CITY OF ALBUQUERQUE

**Re: Cielito Lindo
5109 Central NW
30-Day Temporary Certificate of Occupancy- Transportation Development
Transportation Development Final Inspection**
Engineer's/Architect's Stamp dated 12-05-16 (K11-D085)
Certification dated 10-03-17

TCL
SHEET NO:
A1.2

SITE PLAN

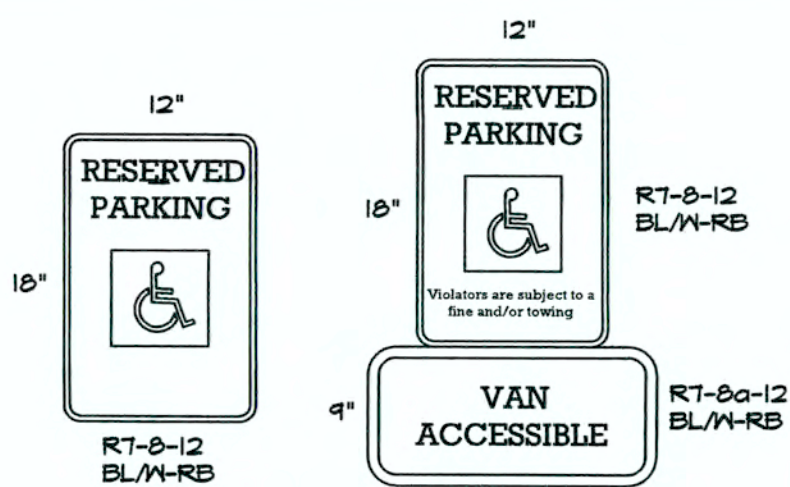
1. Per the zoning code, a 6 ft. wide ADA accessible pedestrian pathway is required from the public sidewalk to the building entrances. Please clearly show this pathway and provide details.

2. The parking spaces to the north of the site must be striped to 18 feet in length.

- THE PARKING STALLS TO THE NORTH HAVE BEEN RE-STRIPED
- THE MOTORCYCLE PARKING AND PARALLEL PARKING TO THE EAST HAVE BEEN STRIPED
- THE MOTORCYCLE PARKING SPACES HAVE BEEN DESIGNATED WITH AN UPRIGHT SIGN ON THE WALL
- THE ARROWS SHOWING TRAFFIC FLOW AND THE WORD EXIT HAVE BEEN STRIPED
- A BICYCLE RACK HAS BEEN INSTALLED
- AN ADA PARKING SIGN 'VIOLATORS ARE SUBJECT TO A FINE AND/OR TOWING' HAS BEEN ADDED
- THE 6FT CONNECTION FROM THE SIDEWALK TO THE BUILDING IS **STILL** TO BE ADDED FOR ACCESSIBILITY
- THE EXIT DRIVE ON THE NORTH OF THE PROPERTY IS **STILL** TO BE MADE TO MATCH THE SITE PLAN AND DRIVE AISLE
